Access Compliance Report

Public Rights-of-Way

Intersection ID: 42466	Main Street: KENSINGTON PALACE LN	Cross Street: KINGS CROWN WY	Location: S
ADA ID: CBE47BC4BF64	Ramp Type: PerpDiag	Initial Pass/Fail: Fail	Overall Compliance: No
Severity Score: 47.5			
Codes/Mitigation Info/Possible Solution		Field Measurements/Component Compliance

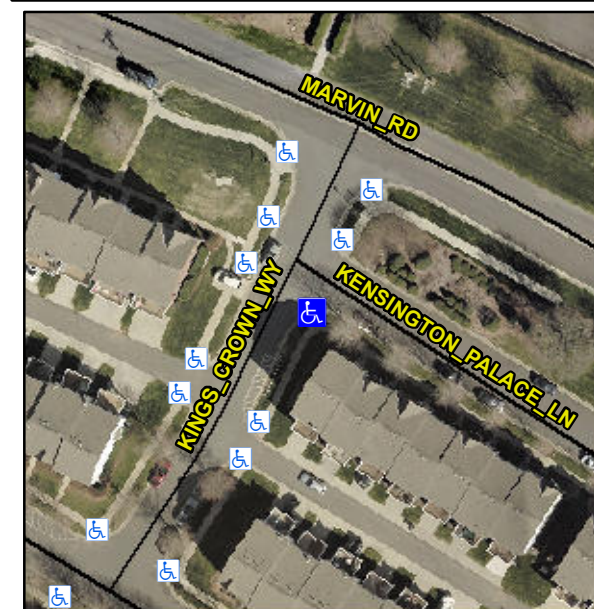
R304.5.1, R304.2.2

Compliance	Description	Data	Compliance	Description	Data
N/A	Ramp Length (in)	68.0	No	Ramp Slope (%)	9.0
No	Ramp Width (in)	28.0	Yes	Ramp XSlope (%)	1.2
N/A	Flare Type LT	N/A	N/A	Flare Type RT	N/A
N/A	Flare Slope LT (%)	N/A	N/A	Flare Slope RT (%)	N/A
N/A	Flare Traversable LT?	N/A	N/A	Flare Traversable RT?	N/A
N/A	Landing Length (in)	N/A	N/A	DWS Provided?	N/A
N/A	Landing Width (in)	N/A	N/A	DWS Contrast?	N/A
N/A	Landing Slope (%)	N/A	N/A	DWS Length (in)	N/A
N/A	Landing X Slope (%)	N/A	N/A	DWS Full Width?	N/A
N/A	Landing Curb? (Y/N)	N/A	N/A	DWS Offset (in)	N/A
N/A	Shared Landing?	N/A			
N/A	Gutter Ponding?	N/A	N/A	Gutter Slope (%)	N/A
N/A	Gutter Lip Ht (in)	N/A	N/A	Gutter X Slope (%)	N/A
N/A	Painted X Walk1?	No	N/A	Painted X Walk2?	No
	X Walk 1 Direction	To NE		X Walk 2 Direction	To NW
N/A	X Walk 1 Width (in)	N/A	N/A	X Walk 2 Width (in)	N/A
	X Walk 1 Slope (%)	3.8		X Walk 2 Slope (%)	4.3
	X Walk 1 X Slope (%)	3.9		X Walk 2 X Slope (%)	4.5

Remove & Replace Curb Ramp With Two New Directional Ramps or Equivalent.
